Occupational Risk Consequences of the Department of Energy's Approach to Repository Design, Performance Assessment and Operation in the Yucca Mountain License Application

1018058

Technical Update, August 2008

Figure 6 - 1
DOE Seismic Hazard Curve Adapted for Post-closure Use [reproduced from Stepp et al. (2001), Figure 1.7-7]

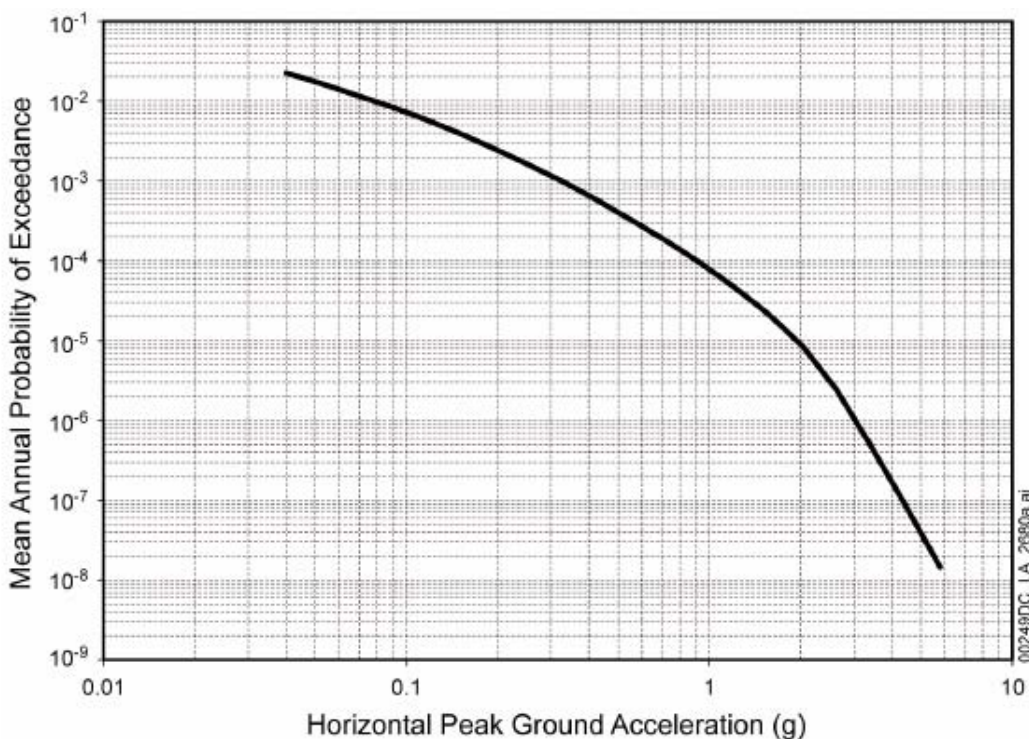
DOE uses ground motions estimated from its Yucca Mountain Probabilistic Seismic Hazard (PSH) model (Stepp et al. 2001). The seismic hazard curve in Stepp et al. (2001) is reproduced here as Figure 6-1. At return periods of 10^6 years, the Yucca Mountain PSH model predicts a mean PGA and PGV of 3g and 400cm/sec, respectively. These are ground motions that exceed the largest magnitudes ever recorded in the world, so there is some uncertainty as to whether they are physically realistic (Bommer et al. 2004). The PGA curve (presented in Figure 1.7-7 of DOE, 2008b) and reproduced here as Figure 6-1, is an extrapolation of the PSHA curve to 10^{-6} /year and beyond. It is important to recognize that a statistical distribution is just a model of observed data, and extrapolation beyond the range of the data may not be valid. EPRI asserts that the extrapolation of the maximum horizontal acceleration is beyond the region that could be supported by the strength of the rock and soil at Yucca Mountain. In a review of the results of this PSHA, an expert panel convened by the USGS (Hanks, et al., 2006), concluded the following:

This statement reflects the fact that even the authors of the ground motion assessment at Yucca Mountain believe that their results are too high and not credible for design. Their use is only recommended for sensitivity studies. Therefore, it is reasonable to conclude that the consensus in the community of earthquake professionals that ground motion estimates at Yucca Mountain are too high at probabilities of 10^{-6} /year and should be lower.

Figure 6 - 2

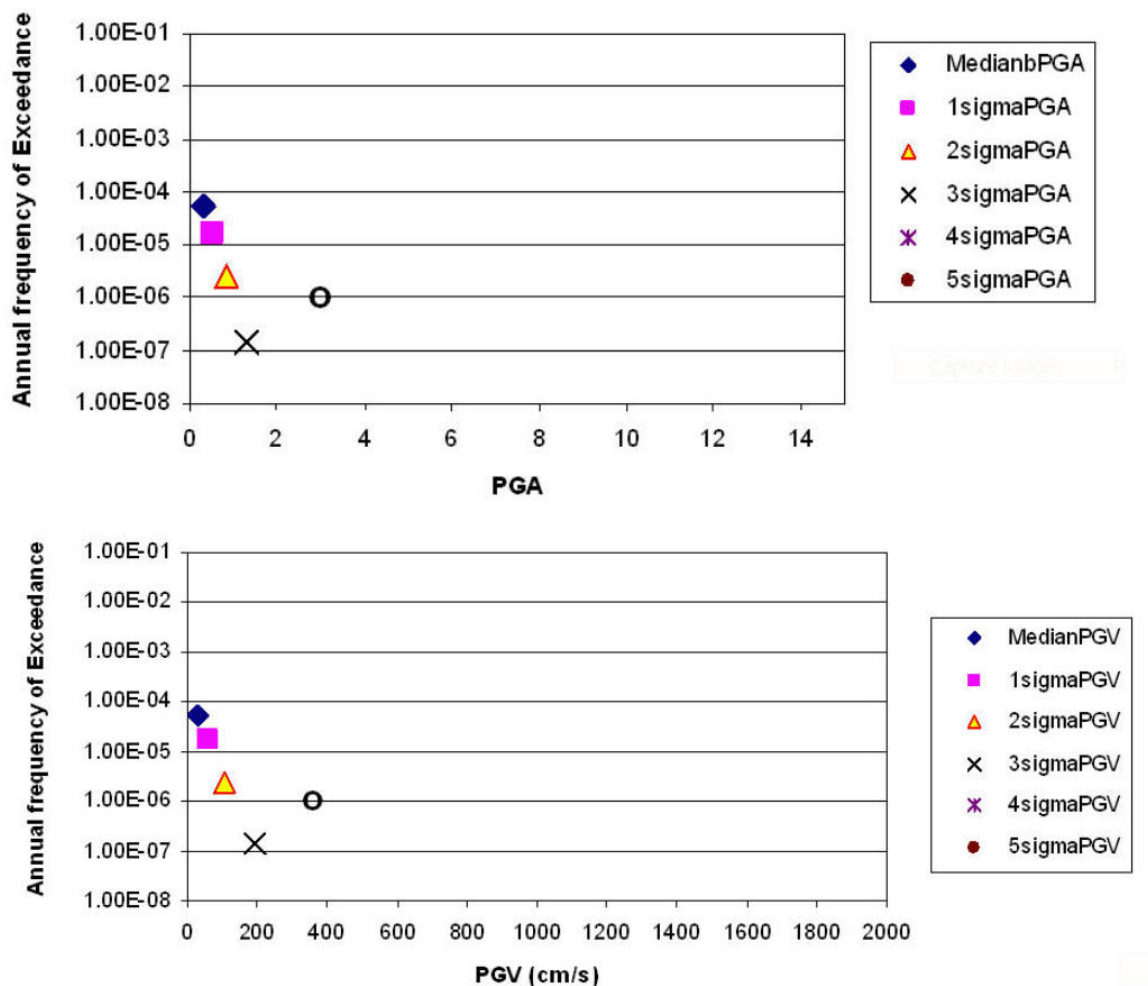
Logically, the closest, most active earthquake sources to Yucca Mountain should be responsible for the largest ground motion levels, and EPRI's analysis compared the ground motion levels of these sources to those of the Yucca Mountain PSH model (EPRI, 2006b). Therefore, EPRI considers the Solitario Canyon Fault (SCF) to be the most important fault upon which to base future seismic activity estimates. EPRI also considers one "background fault" in its analyses (EPRI, 2006b).

Figure 6-2 shows EPRI's estimates of the annual frequency of exceedance for PGA and PGV for the SCF and a background earthquake. Each horizontal line of three matching symbols on Figure 6-2 reflects the range of magnitudes estimates for the SCF (EPRI 2006b, Table 2-1). The open circles on the graphs represent the mean PGA and PGV for the 10^6 year return period from the Yucca Mountain PSHA (Stepp et al., 2001). The analysis shows the PGA to be about 0.7 to 1g for the SCF at the 10^{-6} /yr annual frequency of exceedance, (10^6 year return period), considerably less than the 3g estimated from the Yucca Mountain PSH model for the same return period. A PGV of 70 to 160 cm/sec is estimated for the SCF at the same annual frequency of exceedance or return period, considerably less than the 400 cm/sec derived from the Yucca Mountain PSHA. Similar results are obtained for the background earthquake (Figure 6-2).

EPRI's hazard estimates for the Solitario Canyon Fault (upper figure) and background earthquake (lower figure) sources. The open circles show for comparison the mean values for the 10^{-6} /year annual frequency of exceedance (10^6 year return period) from the Yucca Mountain probabilistic seismic hazard model (Stepp et al. 2001).

Figure 6 - 3
Finite Element Model and Analysis Setup for Impact due to Rockfall (taken from Figure 12-1 in EPRI (2005))

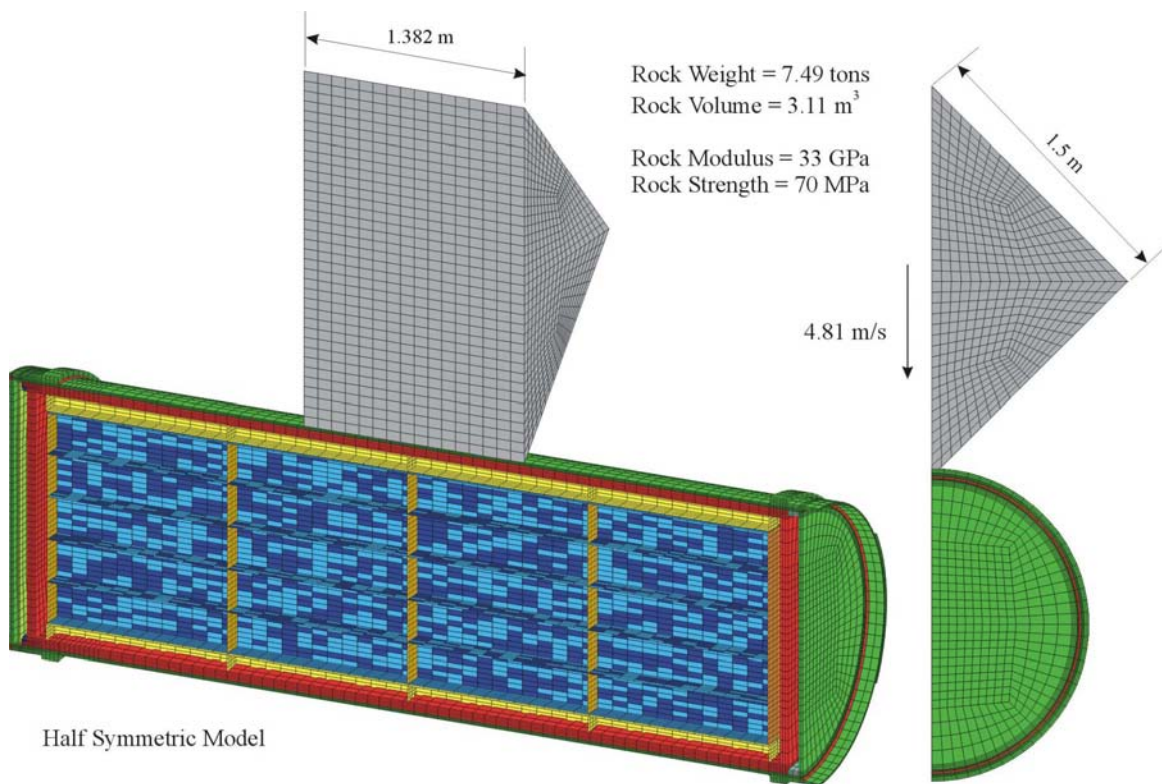
For dynamic loading, EPRI (2005b) conservatively assumed that a large rock block is ejected directly onto the top of a bare WP (i.e., without the DS present), as shown in Figure 6-3. EPRI used an Alloy 22 thickness of 20 mm. The rock block EPRI modeled was assumed to be 7.49 metric tons with a volume of 3.11 m³. This size of rock is the largest size in a representative grouping considered to have a reasonable probability of occurring for the maximum PGV of 2 m/s that EPRI has determined should be associated with a future seismic event near the Yucca Mountain site. This block was assumed to be ejected with a downward velocity of 2 m/s. Furthermore, EPRI (2005b) conservatively assumed that the rock block struck the unprotected WP on a knife edge (see Figure 6-3). EPRI has concluded that even in the event of the

Hence, it is EPRI's position that dynamic rockfall directly onto a WP – without the presence of a DS – will not cause any additional damage compared to the case for which a DS was present. Thus, drips shields are not needed to protect a WP from dynamic rockfall.

Figure 6 - 4
Derived Cumulative Failure Curves for Zircaloy Cladding (EPRI, 2000)

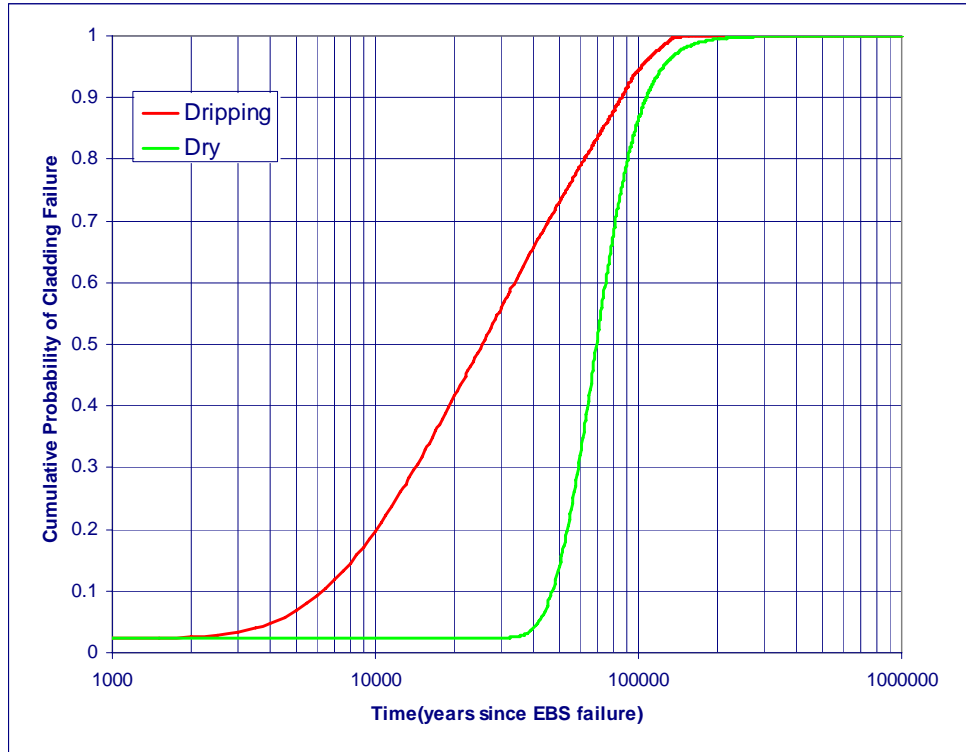
EPRI does find that there is sufficient basis for taking credit for the performance of the CSNF cladding in its TSPA model (EPRI, 2000). Available data on the corrosion of zircaloy CSNF cladding were evaluated to derive an estimated cumulative failure curve as a function of time (Figure 6-4). It was assumed that approximately 2% of the cladding was failed prior to emplacement in a repository. After eventual failure of the waste package/EBS, two corrosion modes for the cladding were considered: (1) general corrosion under dry (moist air) conditions, and (2) general corrosion under dripping conditions. At 10,000 years after EBS failure, about 20% of cladding was projected to have failed under dripping conditions and no additional cladding failures were predicted to occur under dry conditions (EPRI, 2000).

Figure 6 - 5
Comparison of EPRI's Base Case (a) and No Drip Shield (b) TSPA Results

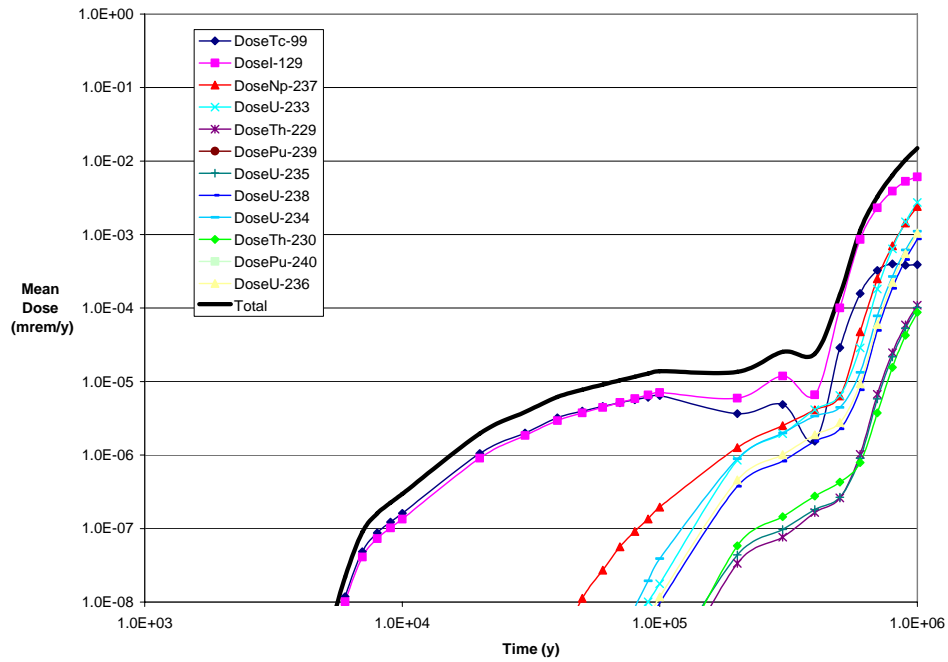
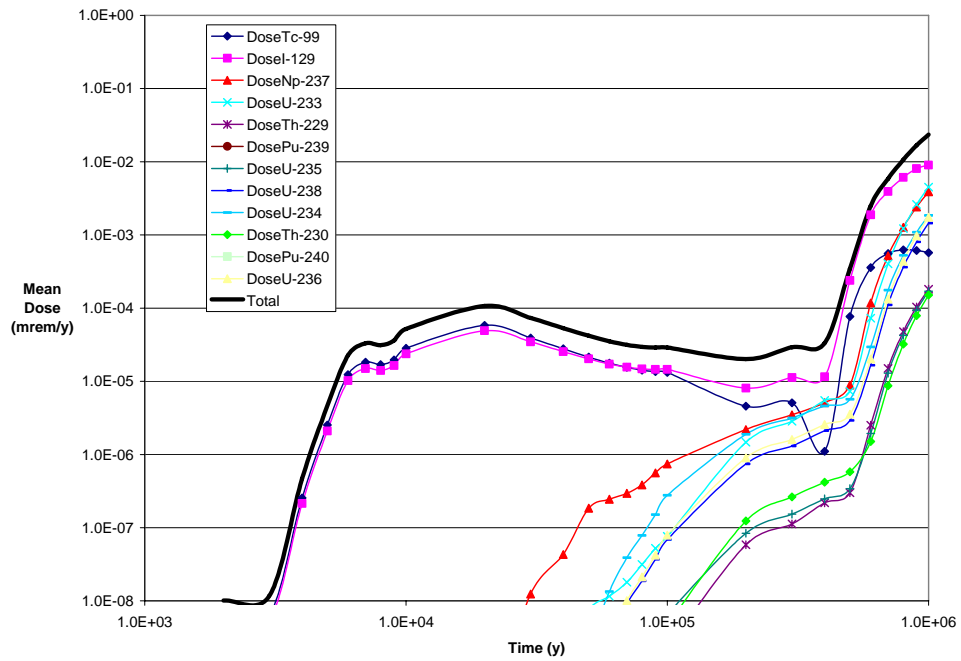
EPRI performed a TSPA analysis using its IMARC code to compare EPRI's Base Case (drip shields present) and a sensitivity study for which EPRI assumed the drip shields were not present. Figure 6-5 shows the IMARC results for the Base Case (Figure 6-5a) and that for no drip shields (Figure 6-5b). There is a moderate increase in doses at early times associated with the waste package that is assumed to be initially failed owing to manufacturing defects. It is noteworthy that even in the EPRI analyses, the assumption of one initially failed waste package is a conservatism as the expected value of waste package failures from manufacturing defects is

significantly below one. The change in peak dose without the presence of the drip shields is negligible, and is still well below the limits established in the proposed EPA/NRC standards.

Figure 7 - 1
DOE Horizontal Seismic Hazard Curve [adapted from DOE 2008b, Figure 1.1-89]

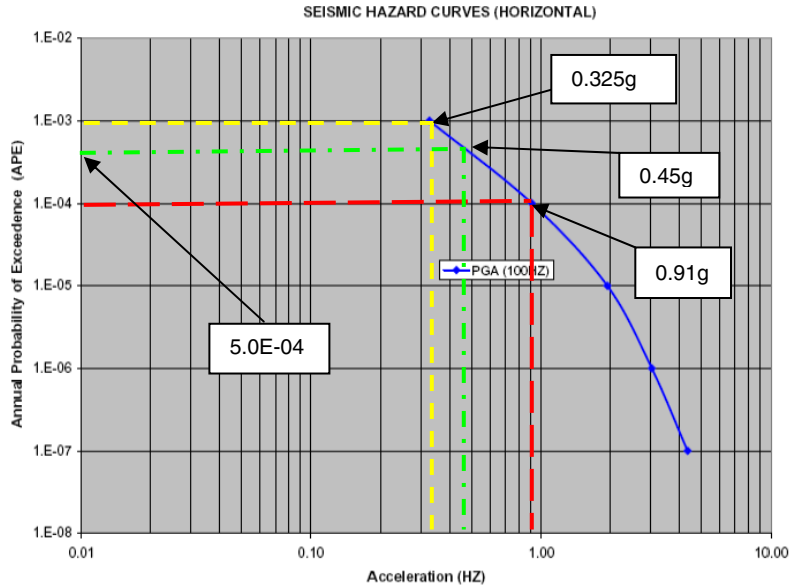
- Events with a mean annual probability of exceedance (MAPE) of 5×10^{-4} (2,000-year return period), designated as Category 2 events. (0.45g, as shown on Figure 7-1)
- BDBGM (Beyond Design Basis Ground Motion) are events with a MAPE of 10^{-4} (10,000-year return period). (0.91g, as shown on Figure 7-1)

Figure 7-1 (BSC, 2007a, p. 75) shows the horizontal seismic hazard curve that DOE is using for the YMP. The figure shows the values of horizontal peak ground acceleration (PGA) at 100 Hz applicable to the design of the surface facilities. The critical evaluation for safety purposes is the Beyond Design Basis Ground Motion (BDBGM) event, which is 0.91g for the return period of 10,000 years.

Figure 8 - 1
 DOE estimates of RMEI mean annual dose for the 0 to 10,000- (upper figure) and 0 to 1,000,000- year (lower curve) time frames (taken from Figure ES-58 in DOE, 2008b).

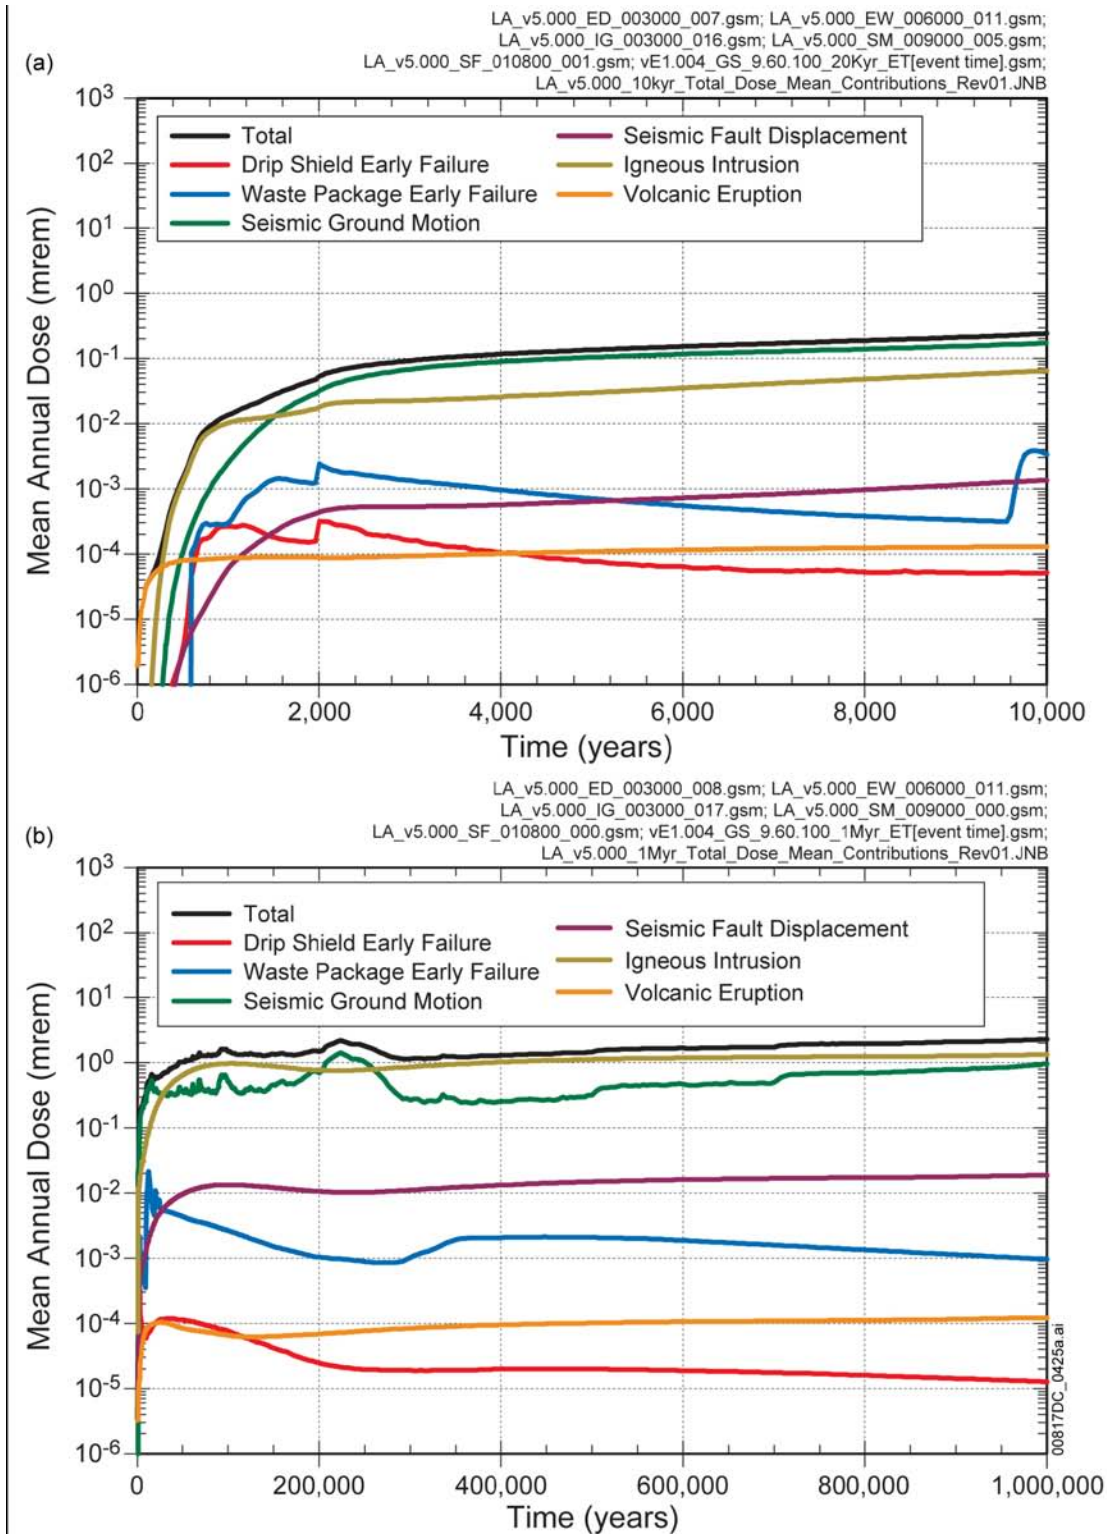
As shown in Figure 8-1, DOE's overestimate of post-closure seismic risk and repository performance effects has caused DOE to find that a major contributor to peak RMEI dose is due to seismic ground motion. While it is not possible to estimate the results DOE would have produced if it had used more reasonable seismic risk and repository performance effects assumptions, it is likely the dose rate estimate for this scenario would be lower, perhaps considerably so. If the igneous intrusion and eruptions scenarios had been eliminated from consideration, as EPRI states is appropriate in Section 5 of this report, and more reasonable estimates of seismic risk and repository performance were used, it is quite possible that the resulting total dose estimates DOE would have derived would be as much as two orders of magnitude lower. If so, this would cause DOE's peak dose results to be fairly similar to the results calculated by EPRI (shown in Figure 8-2).

DOE notes that the first peak in its RMEI dose estimate, shown in the lower figure in Figure 8-1, is primarily due to failure of the defense co-disposal waste packages. This peak rivals that of the ~1,000,000-year peak caused primarily by the TADs containing CSNF. While EPRI finds significant conservatisms in DOE's TSPA analyses for both the co-disposal and TAD waste packages, DOE's performance assessment results may cause an unnecessary amount of regulatory scrutiny to be placed on the co-disposal waste package behavior. If so, then the repository licensing process may take longer to complete, thereby resulting in a potential delay in the opening of the repository.

Figure F - 1
Calculated Probability for a Future Igneous Event Intersecting a Repository Located at Yucca Mountain, Nevada

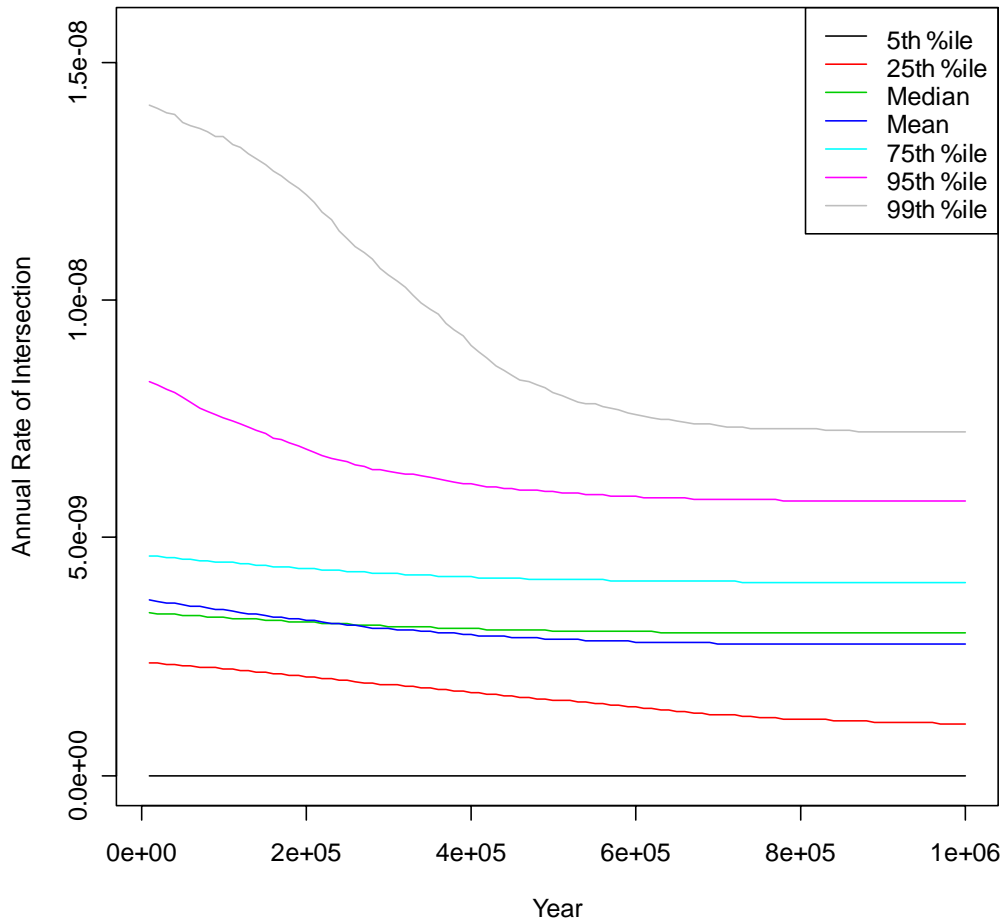
Based on the more recent geological and structural data obtained by the US DOE (i.e., Valentine et al., 2005; 2006; Parson et al., 2006; Valentine and Krough, 2006; Valentine and Perry, 2006; Gaffney et al., 2007; Perry, 2007; Valentine and Perry, 2007; Valentine et al. 2007; Keating et al, 2008) and its own independent spatial and temporal models for controlling factors for the occurrence and eruption of igneous (volcanic) events, EPRI calculated a time-dependent probability of a future event intersecting a repository at Yucca Mountain (see Figure E-1). For a time 10,000 years after repository closure, EPRI's estimated range for igneous-event probability is 0.0 to 1.3×10^{-8} per year, with a mean value of 3.7×10^{-9} per year. For a period 1,000,000 years after repository closure, the estimated range for igneous-event probability is 0.0 to 7.3×10^{-9} per year, with a mean value of 3.0×10^{-9} per year. The decrease in probability values between 10,000 and 1,000,000 years (Figure F-1) is attributable to the time-dependent influence of EPRI's Spatial Cluster Model (i.e., events triggered by regional tectonic episode) imposed on the baseline of the Fault-Induced Cluster Model.
